STATE OF VERMONT AGENCY OF TRANSPORTATION

PROPOSED IMPROVEMENT BRIDGE PROJECT TOWN OF RICHFORD COUNTY OF FRANKLIN BRIDGE NO. 41 ON TOWN HIGHWAY NO. 2

RECORD PLANS	
CONTRACTOR	BLOW & COTE - MORRISVILLE, VT
RESIDENT ENGINEER	CARL GLEASON
CONSTRUCTION BEGAN	MARCH 7, 2008
CONSTRUCTION COMPLETE	MAY 5, 2009
RECORD PLANS BY	CARL GLEASON
I HEREBY CERTIFY THAT ALL THE CONSTRUCTION REQUIRED BY THIS SET OF DRAWINGS HAS BEEN ACCOMPLISHED AS INDICATED HEREIN	
BY	<i>Carl Gleason</i> RESIDENT ENGINEER
DATE	6/14/10
NOTE: Any further information concerning final quantities, amounts or other details relative to this project may be found at Central Files in the electronic archives

DIRECTOR OF PROGRAM DEVELOPMENT	
APPROVED <i>Warren Tripp</i>	DATE 12/16/11
PROJECT MANAGER: WARREN TRIPP	
PROJECT NAME: RICHFORD	
PROJECT NUMBER: BHF 0302 (3) S	
SHEET 1 OF 41 SHEETS

CUSTOMER: BLOW & COTE INC.	JOB NO. 361	DRG. NO. J1
CASCO BAY STEEL STRUCTURES, INC.	75 SPRING HILL ROAD SACO, MAINE 04072	PHONE (207) 282-7360 FAX (207) 282-1179
	REV. 1

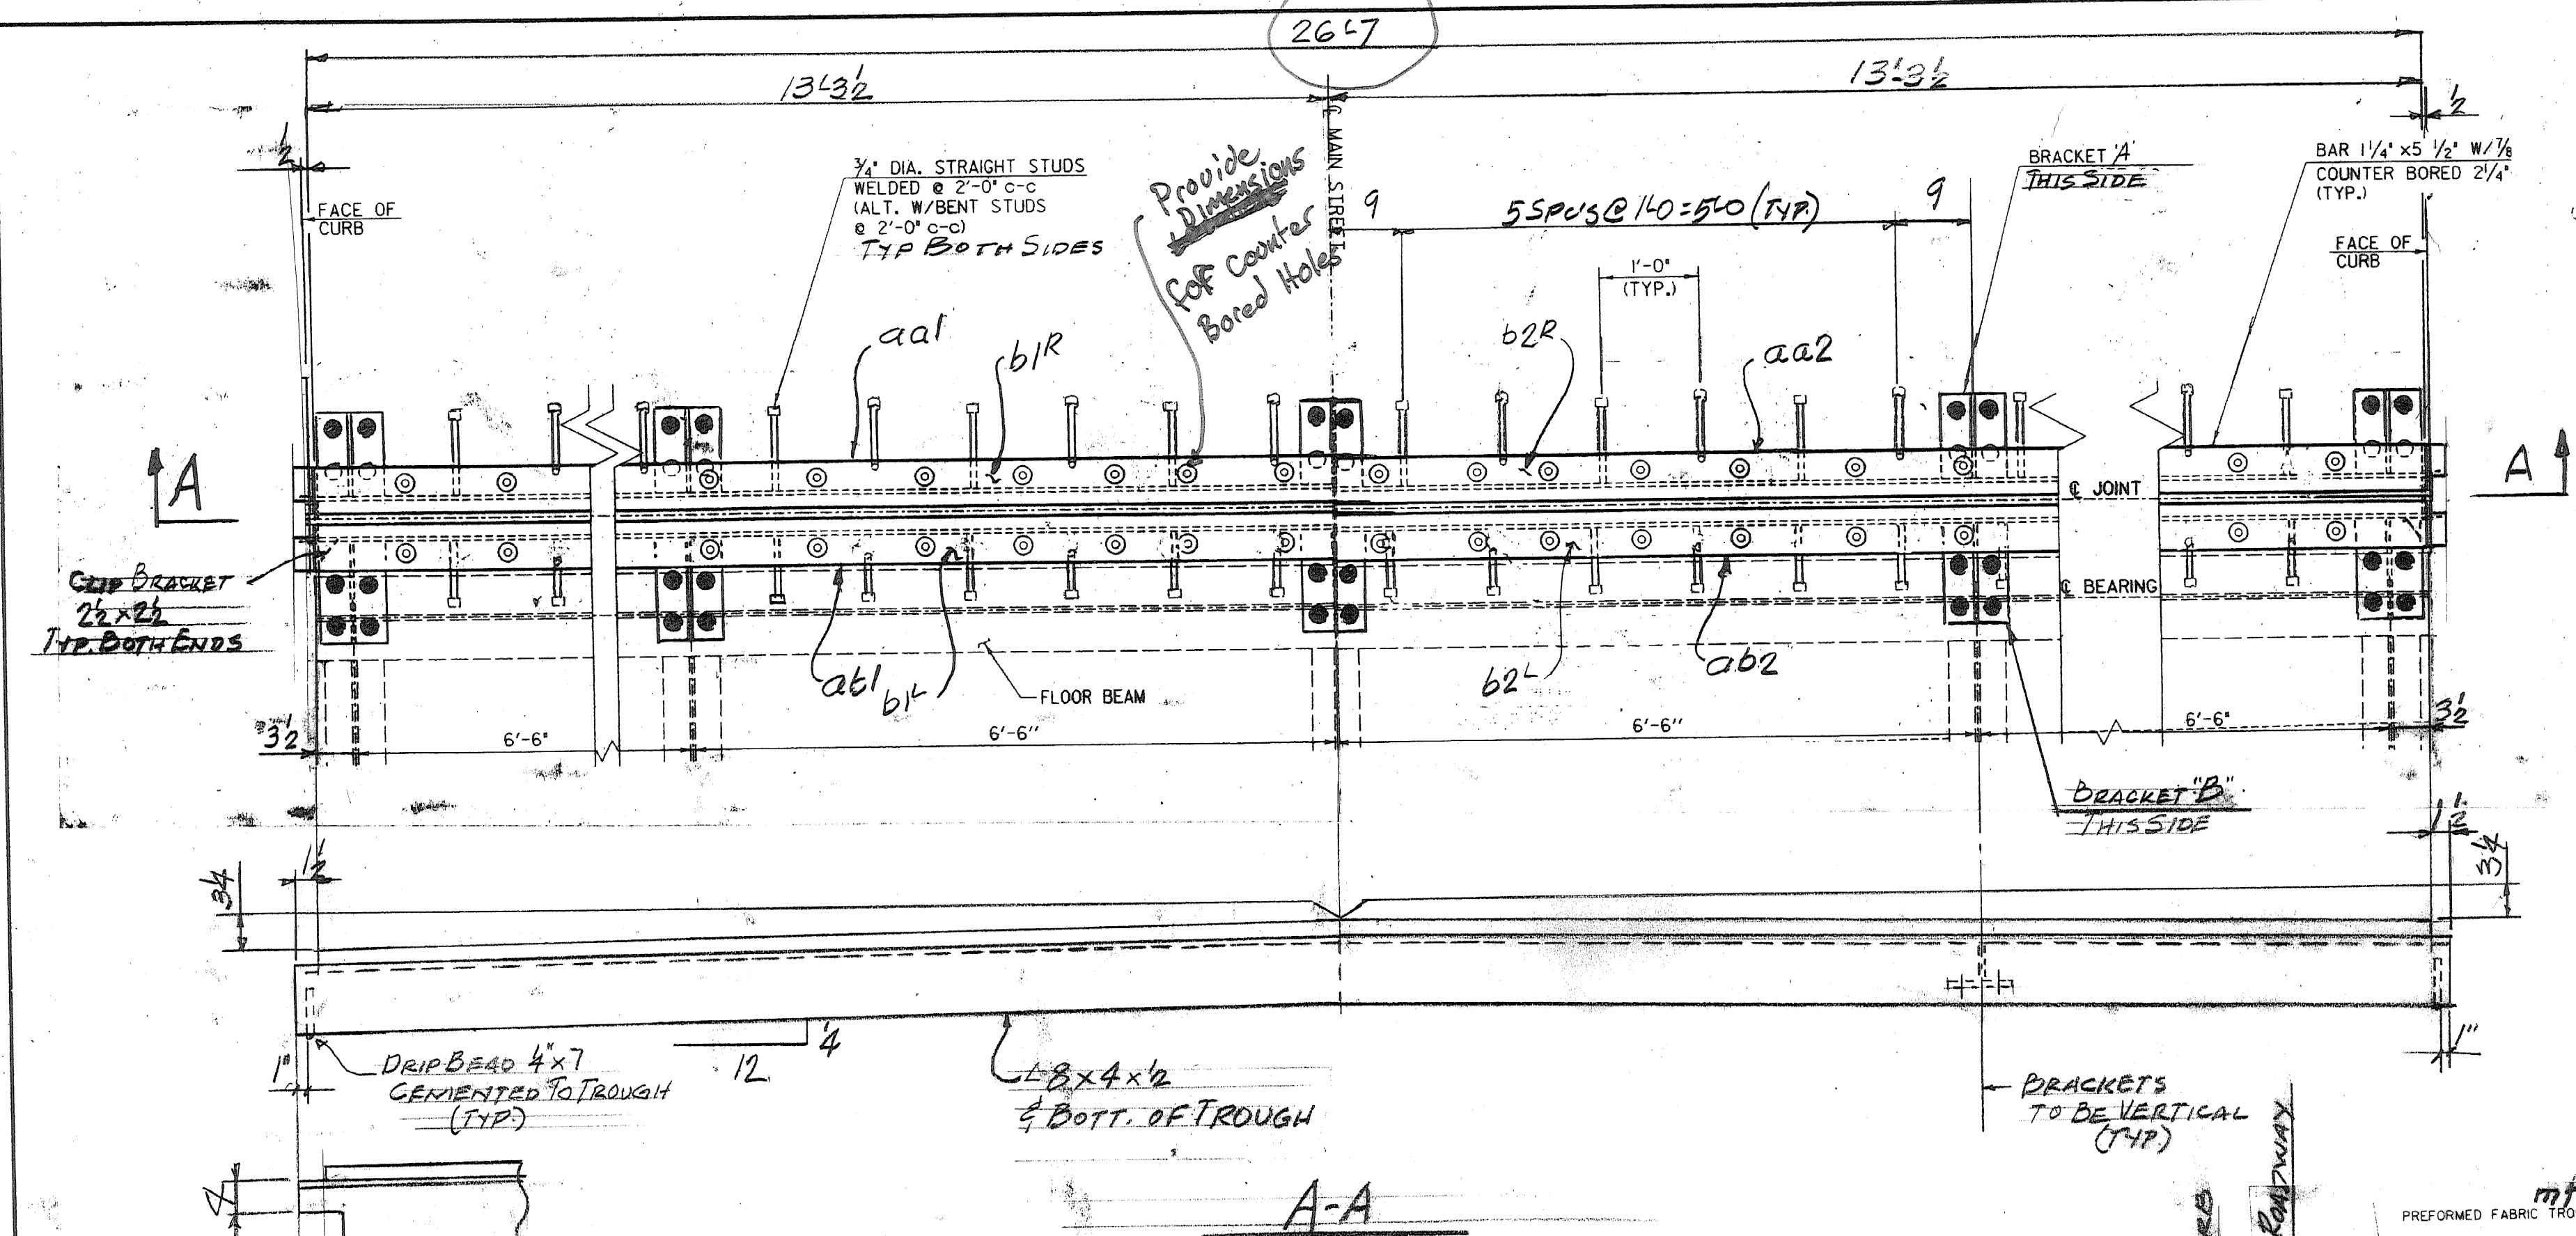
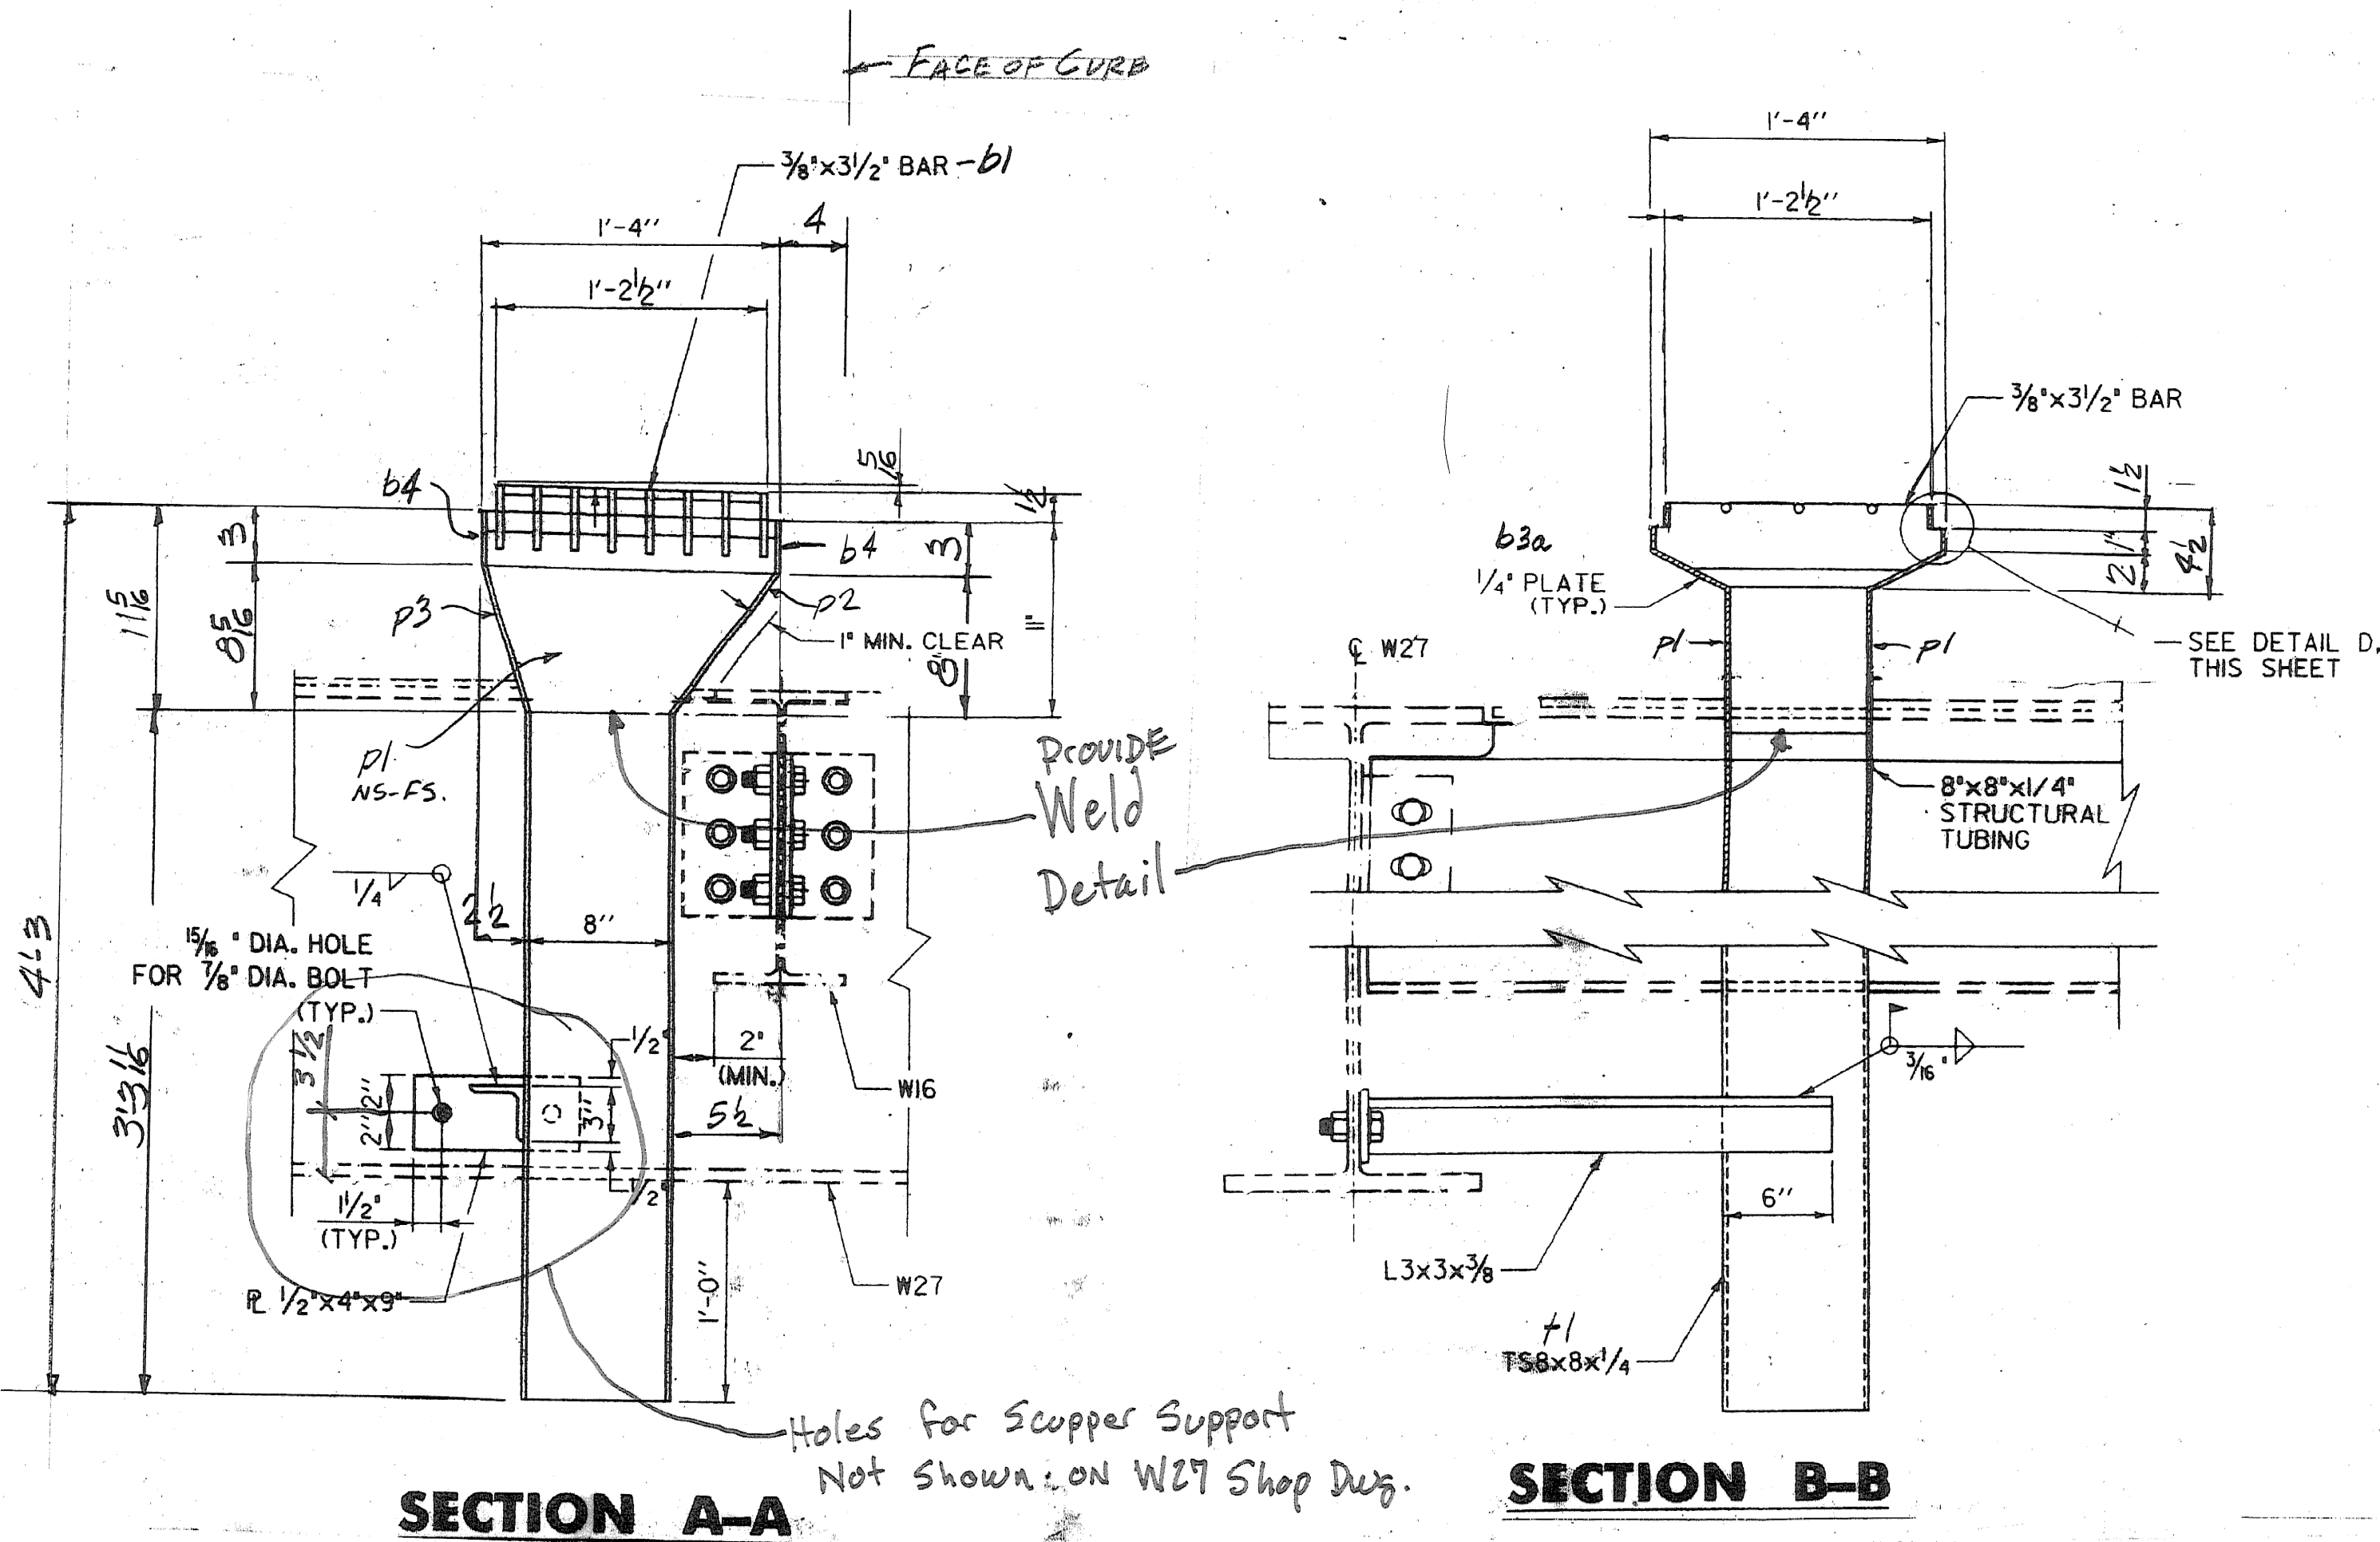
Item 516.11, Bridge Expansion Joint, Vermont, Sheet J 1. This sheet is “**approved as noted**”. Upon receipt of this “as noted” drawing, please make appropriate changes and submit one white print for our use in the record plans for this project.
